ACCESS REPORT

Reference Number: 22353

Client: LAHC

Site Address: 62-66 Pank Parade, Blacktown NSW

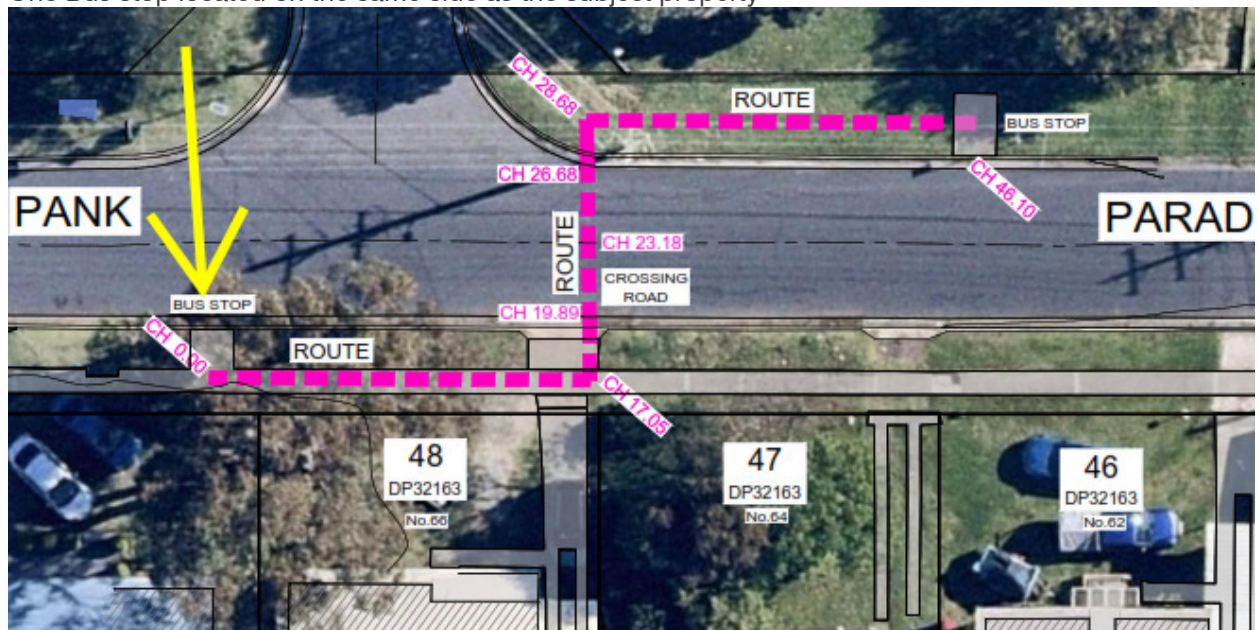
Pedestrian links from the subject site to the nominated bus stops have been provided via kerb ramp on one side and a new kerb ramp will be required to the other side of the road crossing. Note that the nomination of the bus stops is by others.

Bus stop 2

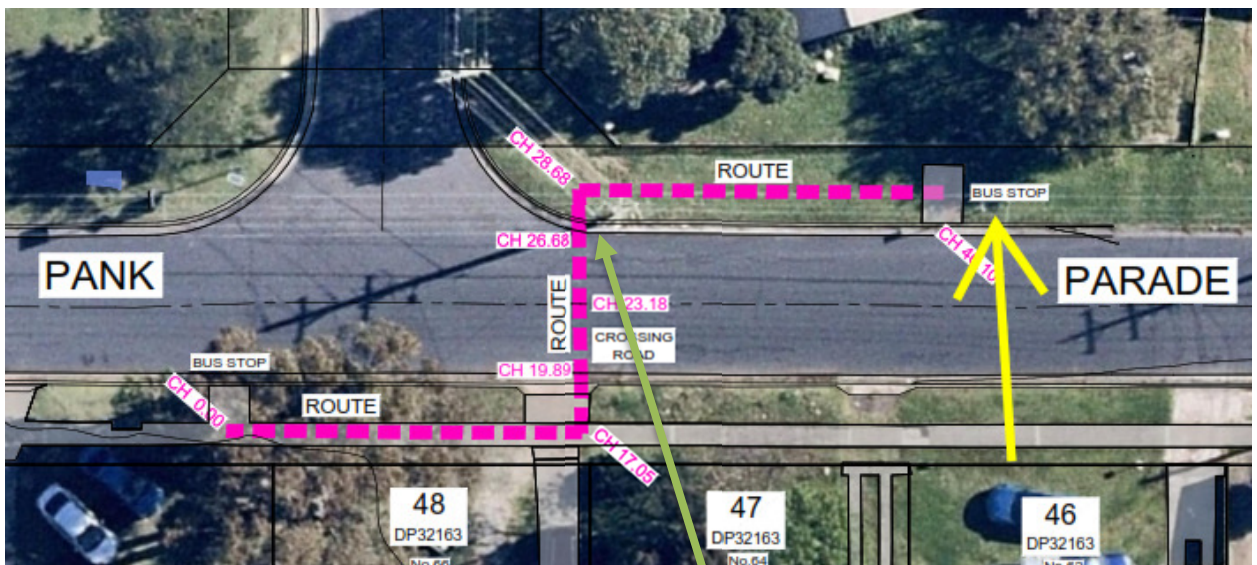
No kerb ramp is provided to the area shown with green arrow and a new kerb ramp will be required
